Town of Hilton Head Island Regular Design Review Board Meeting

AGENDA

SUNSET PAVILION at SKULL CREEK BOATHOUSE

**SECTIONS &
 DETAILS
 A3.1**

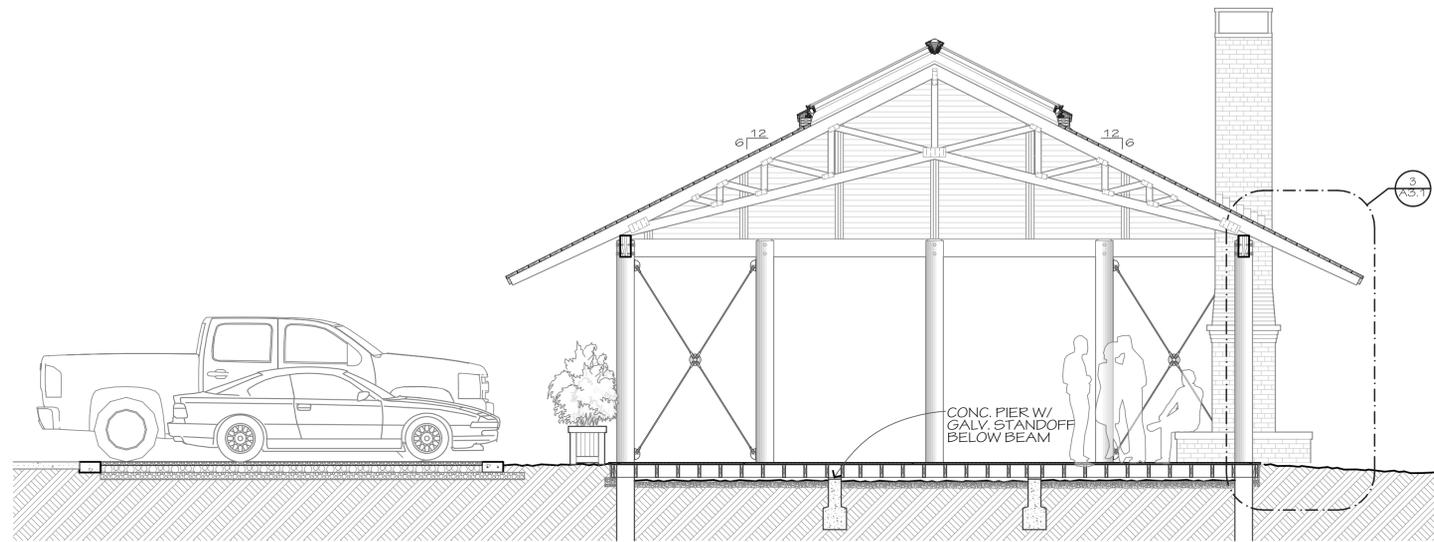
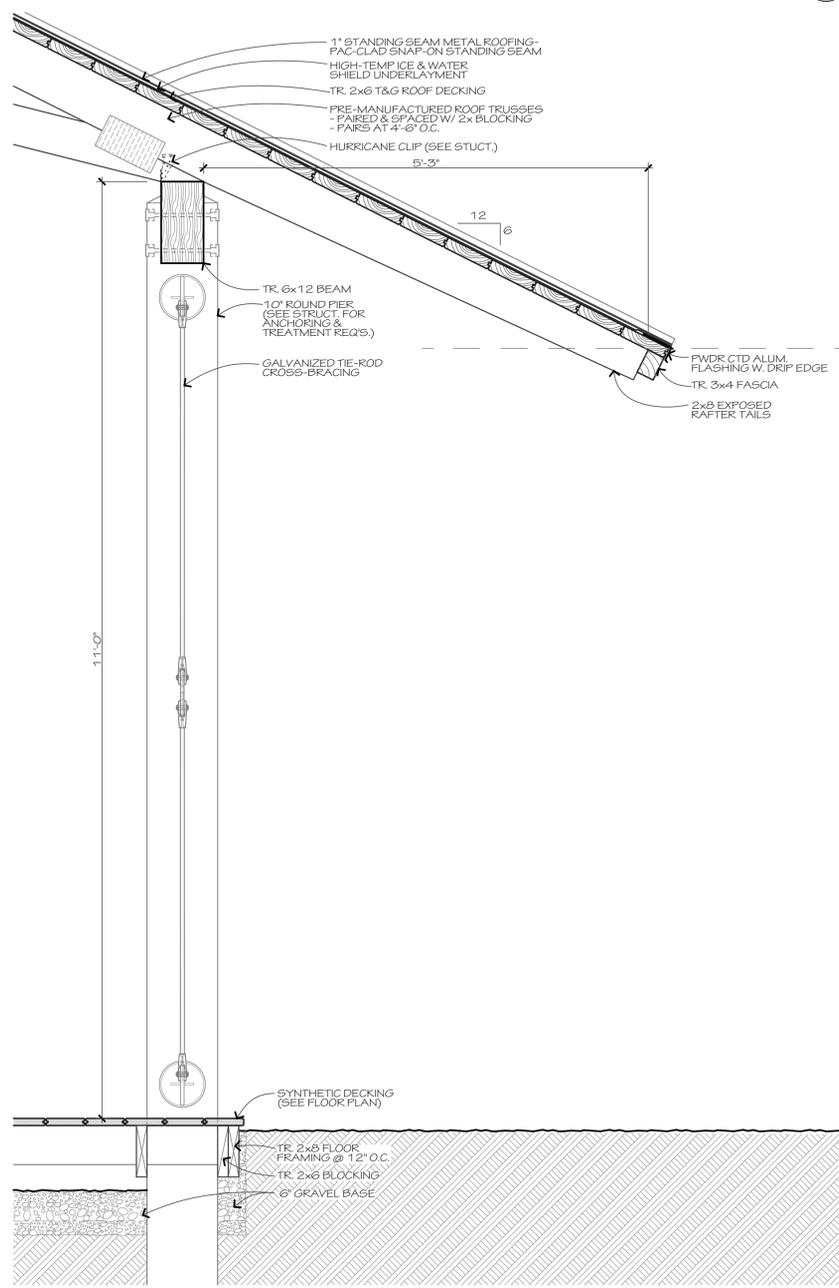
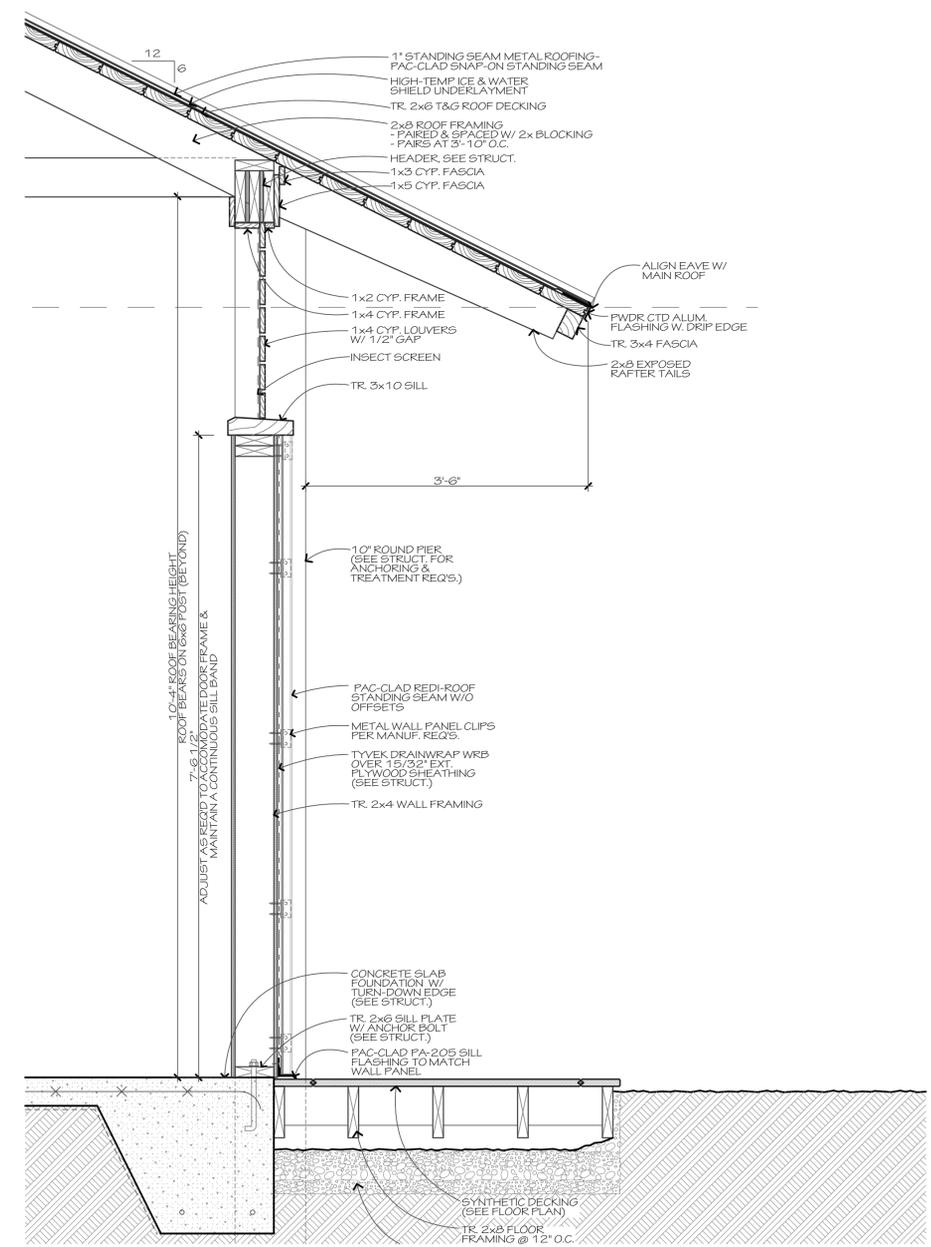
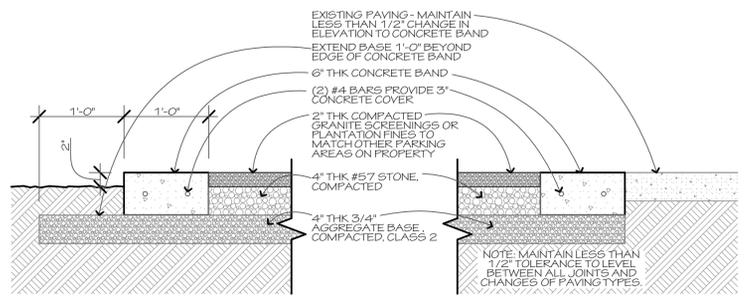
1. Sheet A3.1 details still reference a 5v crimp.
